Product Change Notification / MFOL-17YFJZ381

Manufacturing Change

CCB 6720 Final Notice: Implement new tray design for selected LAN951x, USB2660, USB2517, USB5534B, USB5533B, USB5532B, and USX2065 device families available in 64L QFN (9x9x0.9mm) package at ASE and STA assembly sites.

Simulation Result

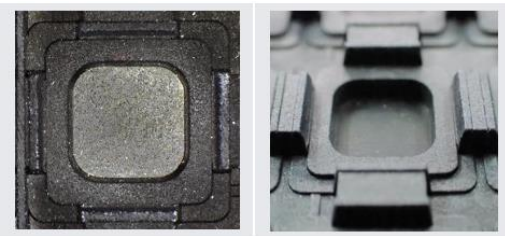
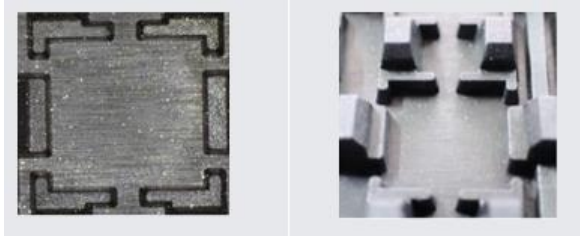
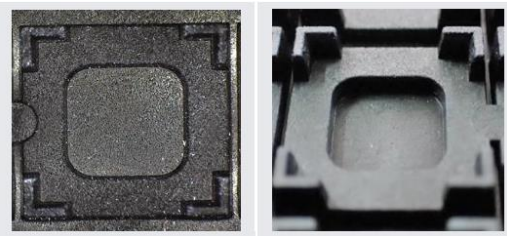
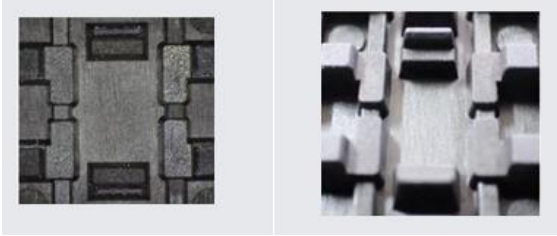
Simulation Result			
Supplier Tray	Result of Simulate I	Result of simulation II	Result of simulation III
DAEWON	No stuck unit	No M/C jam, No unit improperly seat in pocket	 No stuck unit PASS

Pre and Post Summary – Tray Pockets

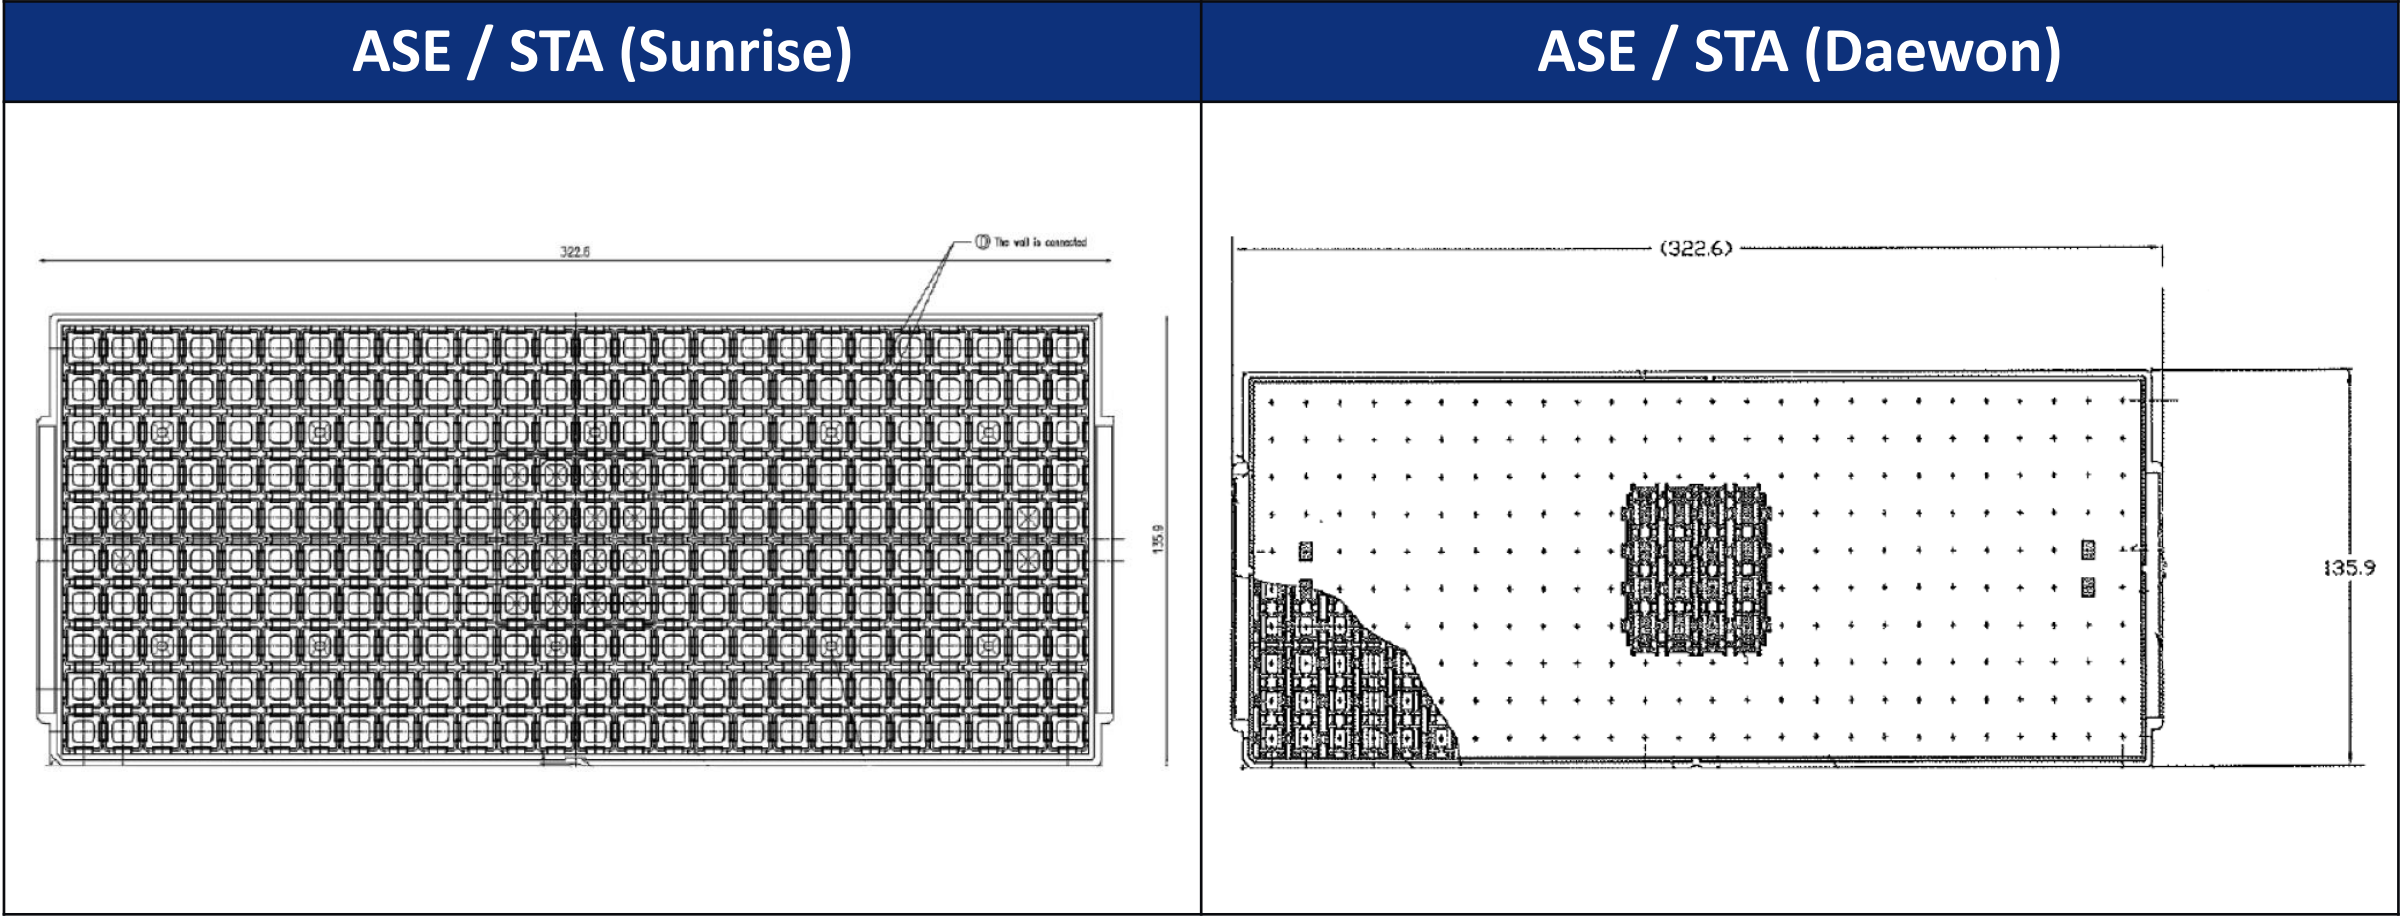
ASE / STA (Sunrise)		ASE / STA (Daewon)	
Top View		Top View

Bottom View		Bottom View

Plant	Supplier	Tray Pockets Dimension
ASE / STA	Sunrise	0.08x2 = 0.16
ASE / STA	Daewon	0.030x2 = 0.06
